CITY OF ALBUQUERQUE

Re: Taco Bell Renovations
4815 4th St NW
Request for 90-Day Temporary C.O. - Accepted
Engineer's Stamp dated: 8-26-15 (F14D071)
Certification dated: ~~NA~~ 2-16-16

GRADING AND
DRAINAGE PLAN

C-101

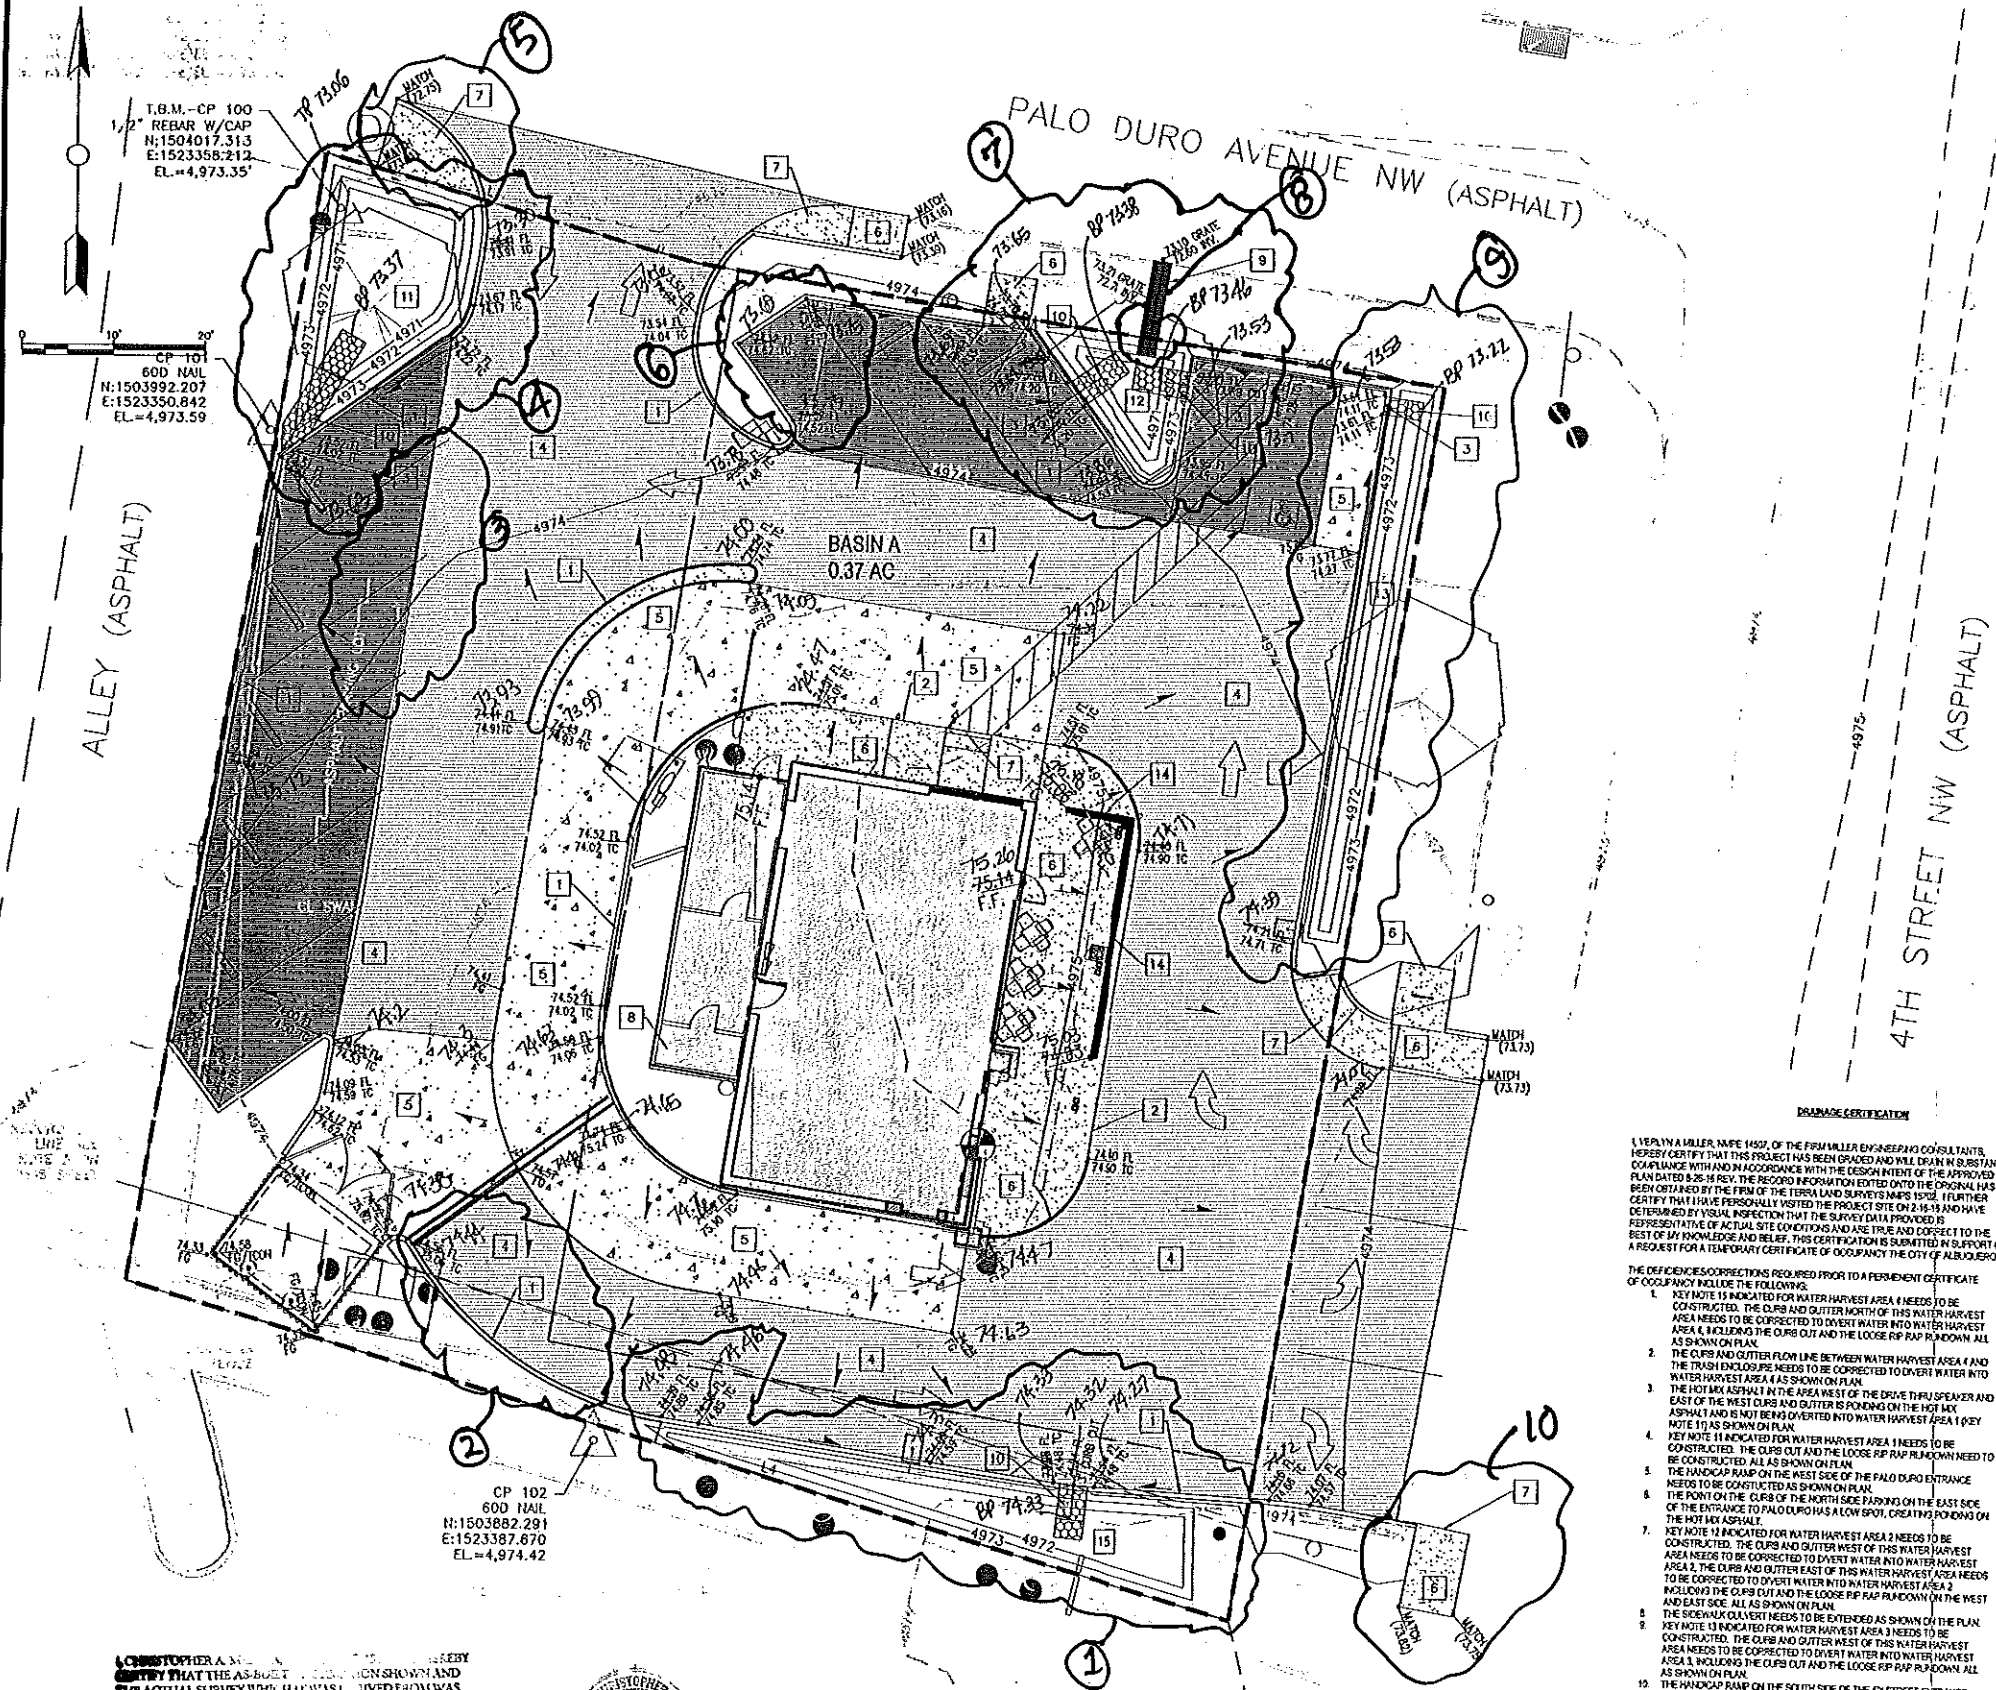
- The sidewalk culvert must be completed. Until it is complete it must remain barricaded with "Sidewalk Closed" signs on both sides starting at each entrance to the site. The bottom of water harvest on this pond needs to be approximately 3'-3" below TOC.
- The pond that diverts to the above mention culvert needs to be graded to flow into the culvert.
- The bottom of water harvest on the NW corner needs to be approximately 3'-3" below TOC.
- The 3' curb cut is missing from this water harvest area.
- The bottom of water harvest on the SE corner needs to be approximately 2'-3" below TOC.
- The bottom of water harvest on the east side needs to be approximately 2'3" below TOC.

1. KEY NOTE 11 INDICATED FOR WATER HARVEST AREA 1 NEEDS TO BE CONSTRUCTED. THE CURB AND GUTTER NORTH OF THIS WATER HARVEST AREA NEEDS TO BE CORRECTED TO DIVERT WATER INTO WATER HARVEST AREA 1 INCLUDING THE CURB CUT AND THE LOOSE RIP RAP RUNDOWN ALL AS SHOWN ON PLAN.

2. THE CURB AND GUTTER FLOW LINE BETWEEN WATER HARVEST AREA 1 AND THE TUSH ENCLOSED AREA NEEDS TO BE CORRECTED TO DIVERT WATER INTO WATER HARVEST AREA 1 AS SHOWN ON PLAN.

3. THE HOT MIX ASPHALT IN THE AREA WEST OF THE DRIVE THRU SPEAKER AND EAST OF THE WEST CURB AND GUTTER IS PONDING ON THE HOT MIX ASPHALT AND IS NOT BEING DIVERTED INTO WATER HARVEST AREA 1 (KEY NOTE 11) AS SHOWN ON PLAN.

4. KEY NOTE 11 INDICATED FOR WATER HARVEST AREA 1 NEEDS TO BE CONSTRUCTED. THE CURB CUT AND THE LOOSE RIP RAP RUNDOWN NEED TO BE CONSTRUCTED. ALL AS SHOWN ON PLAN.

5. THE HANDICAP RAMP ON THE WEST SIDE OF THE PALO DURO ENTRANCE NEEDS TO BE CONSTRUCTED AS SHOWN ON PLAN.
6. THE POINT OF THE CURB OF THE NORTH SIDE PARKING ON THE EAST SIDE OF THE ENTRANCE TO PALO DURO HAS A LOW SPOT. CREATING FLOWWAYS ON THE HOT MIX ASPHALT.

7. KEY NOTE 11 INDICATED FOR WATER HARVEST AREA 2 NEEDS TO BE CONSTRUCTED. THE CURB AND GUTTER WEST OF THIS WATER HARVEST AREA NEEDS TO BE CORRECTED TO DIVERT WATER INTO WATER HARVEST AREA 2. THE CURB AND GUTTER EAST OF THIS WATER HARVEST AREA NEEDS TO BE CORRECTED TO DIVERT WATER INTO WATER HARVEST AREA 2 INCLUDING THE CURB CUT AND THE LOOSE RIP RAP RUNDOWN ON THE WEST AND EAST SIDE. ALL AS SHOWN ON PLAN.

8. THE SIDEWALK CULVERT NEEDS TO BE EXTENDED AS SHOWN ON PLAN.
9. KEY NOTE 13 INDICATED FOR WATER HARVEST AREA 3 NEEDS TO BE CONSTRUCTED. THE CURB AND GUTTER WEST OF THIS WATER HARVEST AREA NEEDS TO BE CORRECTED TO DIVERT WATER INTO WATER HARVEST AREA 3 INCLUDING THE CURB CUT AND THE LOOSE RIP RAP RUNDOWN ALL AS SHOWN ON PLAN.

10. THE HANDICAP RAMP ON THE SOUTH SIDE OF THE 4TH STREET ENTRANCE NEEDS TO BE CONSTRUCTED AS SHOWN ON PLAN.
